Permission sought for a mixed use & residential development on a site area of 6.3Ha, within the Clonburris Strategic Development Zone (SDZ) and in the townland of Cappagh, Dublin 22.

ADDITIONAL INFORMATION

REG. REF. SDZ22A/0010

Fig. 3 – Indicative feasibility for entire CUC-S4 lands.

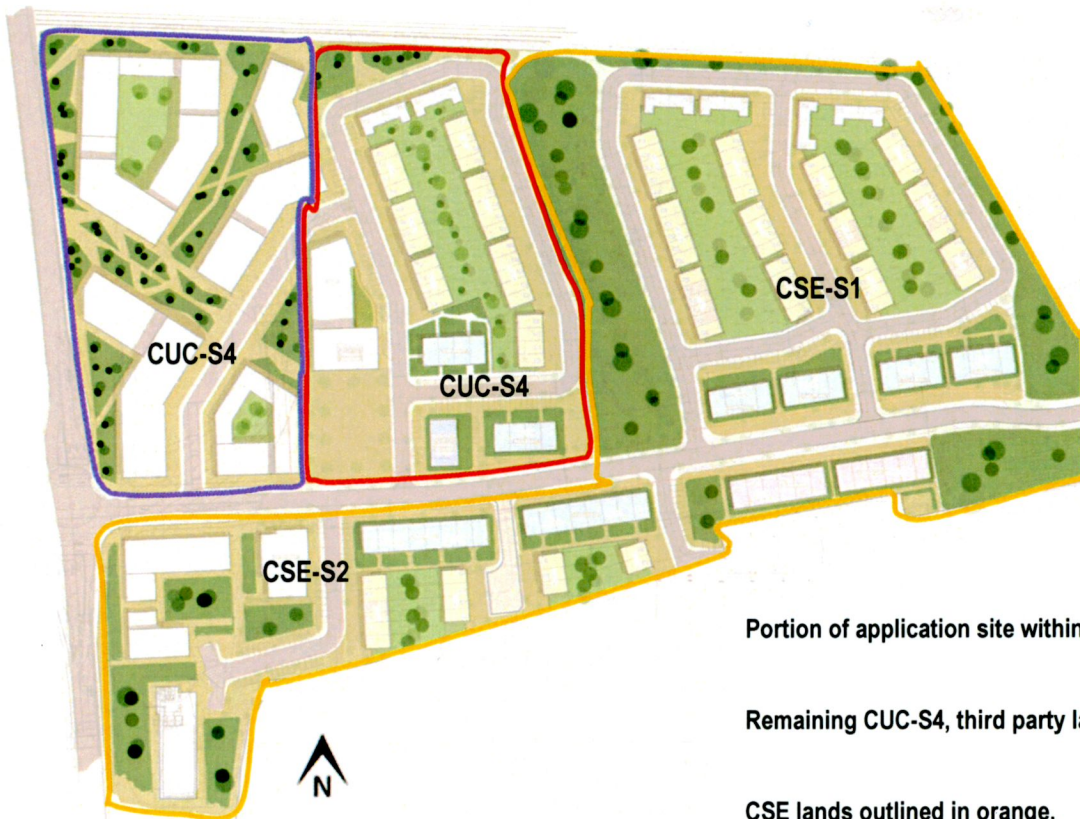
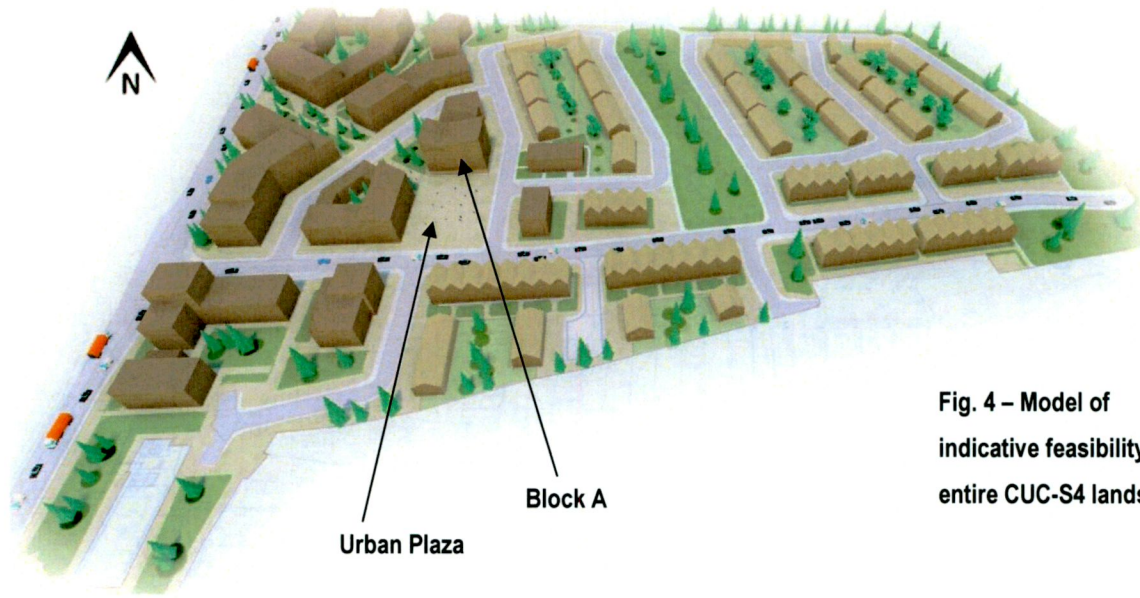
- (a) Housing with lower densities than what would have been envisioned for this development area is proposed. Higher density and mixed use development should be explored in the CUC-S4 area of the site.*

The proposed revised layout has also been considered in the context of the masterplan for the adjacent remaining CUC-S4 lands that lie outside the applicant's ownership. The feasibility demonstrates that the target density for the CUC-S4 lands can be comfortably achieved with the revised proposal and without relying on excessive height - i.e. not greater than 6 storeys.

The above Figs 4 and 5 are massing models with a view looking north across the site. The third party lands to the west/north-west of the application site is included on the model representing the extent of the CUC-S4 area of the SDZ lands. A gradually increasing volume and density is proposed from the public open space park to the east towards the Urban Plaza and the Fonthill Road to the west. It is proposed that this graduation in scale delivers appropriate characteristics to defined open spaces while also delivering target density - i.e. lower density fronting to public parkland, graduating up to higher density fronting onto Urban Plaza and closer to the train station, thus meeting the density parameters of the SDZ Planning Scheme for CUC-S4.

Based on the proposed modelling, a potential net density of 85-90 units per hectare for the CUC 4 lands can be achieved. This is comprised of the proposed 95 no. dwellings on the current application site contained in the applicant's part/ownership of CUC-S4, and c.235 units on the adjacent third party lands to the west. It is envisaged that a quantum of 5,300sq.m of non-residential space [community and employment] can also be provided across the shared landholding.

Fig. 6 – Indicative feasibility for entire CUC-S4 & CSE lands

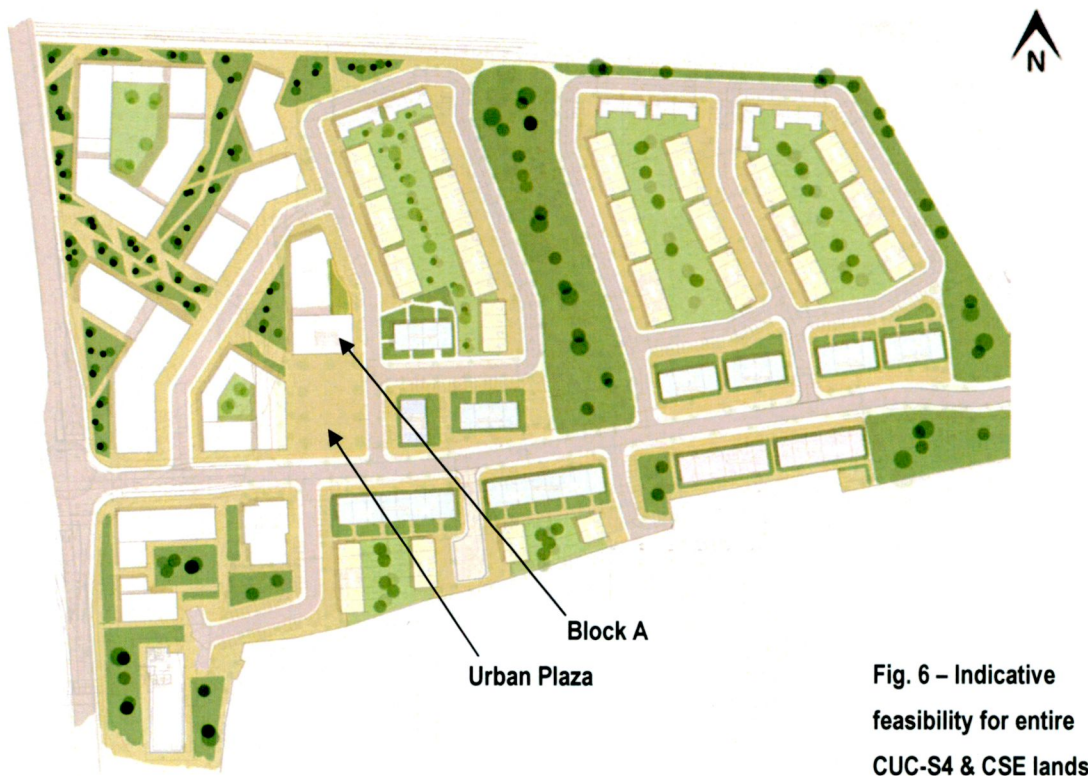
(b) The proposed plaza and surrounding block form should be significantly redesigned in line with the Design Criteria in Table 2.10.3 of the Planning Scheme. A detailed design of the plaza should be submitted, including how it would connect with the remainder of the Clonburris Urban Centre and wider area as indicated in the Planning Scheme. The plaza should be enclosed on more than one side.

It can be seen from the submitted feasibility that a proposed street connection from the plaza / subject application site to the western side of CUC-S4 can be created via a looped link street that would pass the proposed creche and retail/commercial unit in Block A. Development on the western part of the CUC-S4 lands could be configured with enclosed private courtyard parks over basement parking. A diagonal street leading from the plaza toward the train station can be accommodated, catering for pedestrian and cyclist accessibility, in the manner as suggested within the masterplan layout contained in the SDZ Planning Scheme.

Fig. 7 – Model of indicative feasibility for CUC-S4 & CSE lands

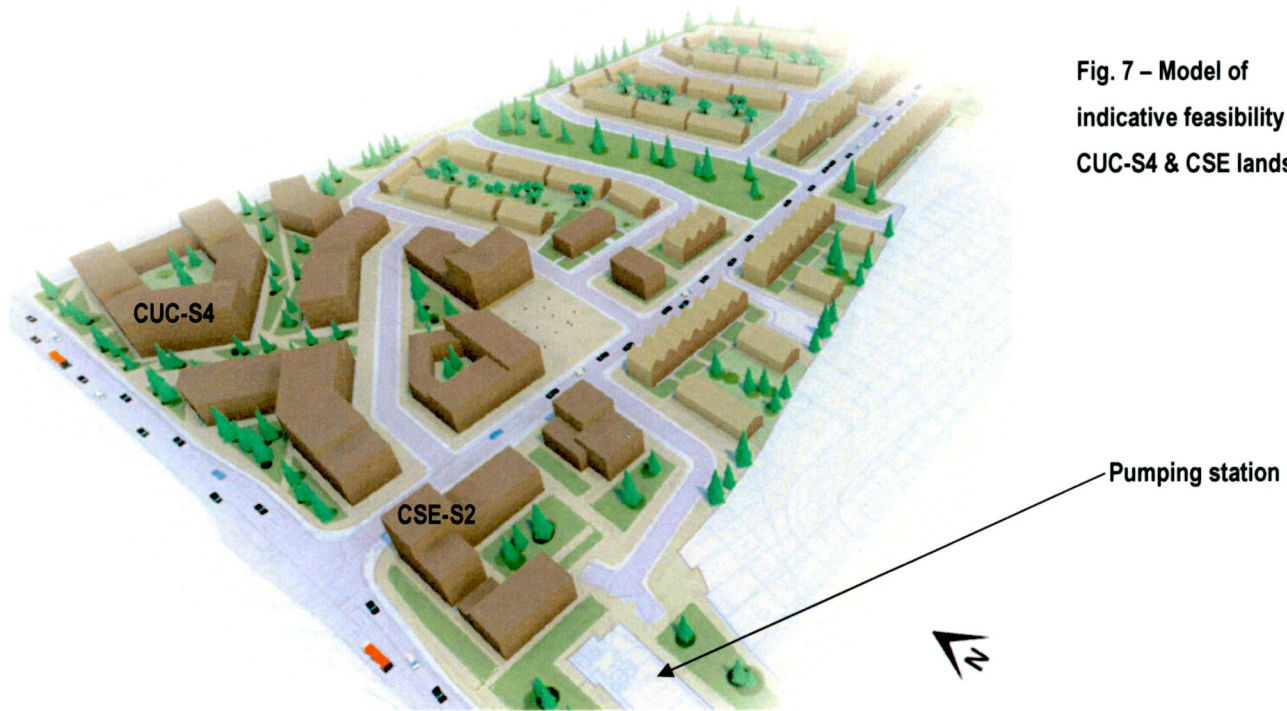
(d) Master planning of how the proposal would integrate with the Planning Scheme and help deliver the rest of the Clonburris Urban Centre is required. The potential future development of the remainder of the CUC-S4 and CSE-S2 subsectors should be indicated. This indicative masterplan should indicate potential future:

For the remainder of the CUC-S4 lands, the masterplan takes into consideration a block form and layout that will knit together with the proposed application to provide a coherent urban form that directly reflects the design intent as set out in the Planning Scheme for this area. The submitted feasibility sets out that the remaining CUC-S4 lands can accommodate c.235 no. units in a series of buildings that would range in height from 3-4-5-6 storeys. This, combined with the current proposal of 95 no. units on CUC-S4 lands provides for a density range of 67-150 units per hectare, which accords with required density range of 67-150 units per hectare, as set out in the SDZ Planning Scheme.

Fig. 7 above is a massing model with a view looking north across the site. The third party lands to the west of the application site are included on the model representing the extent of the CUC-S4 and CSE-S2 sectors of the SDZ lands. A gradually increasing volume and density is proposed from the central public open space park to the east (included in the subject application site) towards the Urban Plaza and the Fonthill Road to the west. It is proposed that this graduation in scale delivers appropriate characteristics to defined open spaces while also delivering target density - i.e. lower density fronting onto public parkland and then graduating up to higher density fronting onto the Urban Plaza and closer to the train station, thus meeting the density parameters of the SDZ Planning Scheme for CUC-S4.

The feasibility allows for street connections from the application site to the adjoining third party lands to the west, thus connecting to the western section via a looped link street that would pass the proposed Block A at its south-western corner, moving north-westwards into the adjoining lands. The feasibility layout allows for the urban plaza to be further enclosed on its western side, but the indicative site layout plan allows a visual connection from the adjoining third party lands to the plaza thus drawing pedestrians and cyclists into the space that will act as a nodal point within CUC-S4. A diagonal street leading from the plaza toward the train station can be accommodated in this manner as suggested within the SDZ masterplan layout. Development on the western part of the lands could also be configured with enclosed private courtyard parks over basement parking.

Fig. 11 – Sample of proposed Communal Open Space Railing

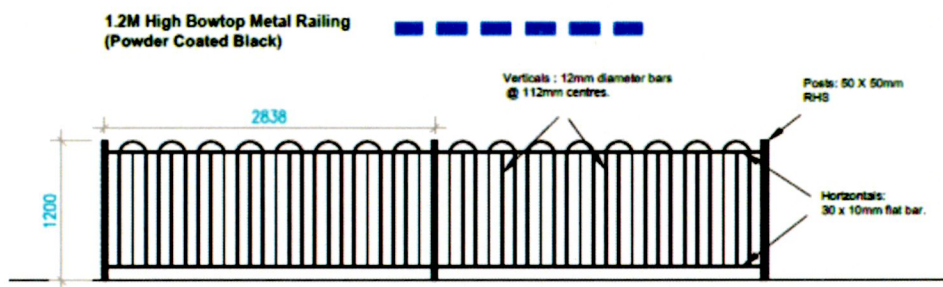
(c) Further detail and a revised design for communal open space should be submitted. This include revised boundary treatment, consideration of sunlight access and how it will tie in with potential development to the west.

A 1.2m railing will be implemented along the boundary of the communal open space, with details of same illustrated on page 3 of the submitted RMDA Additional Information Response document, and the submitted Boundary Plan (drawing no. 02BP) – please refer to same.

The communal open spaces are designed to act as a shared amenity space for the residents of Blocks A and B only, with a specific space designated to each building/block. This space will be for the sole use of the residents of these blocks and to that end a 1.2m railing will be implemented along the boundary of the communal open space to define this space as being associated with the adjoining apartment building but being of a size and type that allows a visual connection both into and out of these communal spaces.

Fig. 15 – Indicative feasibility for entire CUC-S4 & CSE lands demonstrating compliance to the street hierarchy & urban grain of the SDZ Planning Scheme

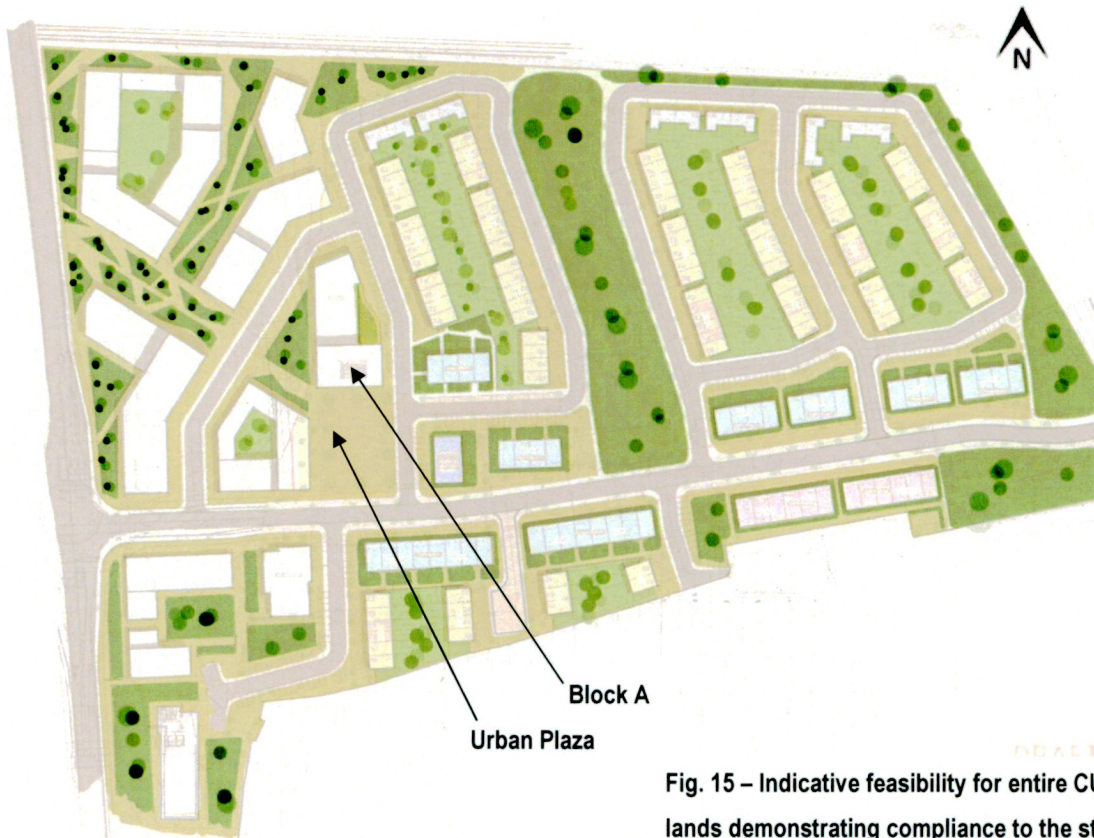
Section 2.2.4 of the Planning Scheme outlines that the centre line and alignment of the Local Streets and Home zones are flexible with the exception of streets with frontages prescribed under Section 3 (Development Areas). In this instance, the application site contains prescribed frontages in the form of Avenue, Park and Railway Frontages (Figure 3.1 refers). The Local Street alignment in the north western part of the site, in CUC-S4, is amended and Local Streets/frontages are not provided around the urban plaza as indicated in the Planning Scheme. This would have Avenue Frontages onto it. This should be provided. The Planning Scheme does not provide for the easternmost cul-de-sac to the south of the Link Road. This should be considered for omission and/ or a detailed rationale provided.

The enclosed revised site layout plan has enlarged the proposed urban plaza and provided building frontage onto it. The lands to the immediate west are in third party ownership, however, as outlined in detail above, the project architects Davey+Smith have prepared the submitted indicative feasibility layout for the remainder of the CUC-S4 lands which demonstrates that future, further enclosure of the plaza can be facilitated. Cognizance has also been paid to section 2.2.4 of the SDZ Planning Scheme, as well as Figures 2.2.1 and 2.4.2 of the Planning Scheme.

Figure 2.4.2 of the Planning Scheme identifies 'Fine Urban Grain' locations in the Planning Scheme. This diagram also identifies fixed building lines, which largely front to main streets with flexible inner lines between blocks, to which the proposed development in CUC-S4 complies. Blocks F and K directly address the main east-west link street to the immediate south. Block A has been amended to provide a more defined and stronger frontage onto the plaza, while the feasibility layout for the remainder of the CUC-S4 lands demonstrate that proposed urban blocks can further enclose the plaza and that proposed local streets can be facilitated and tie into the current proposed site layout plan.
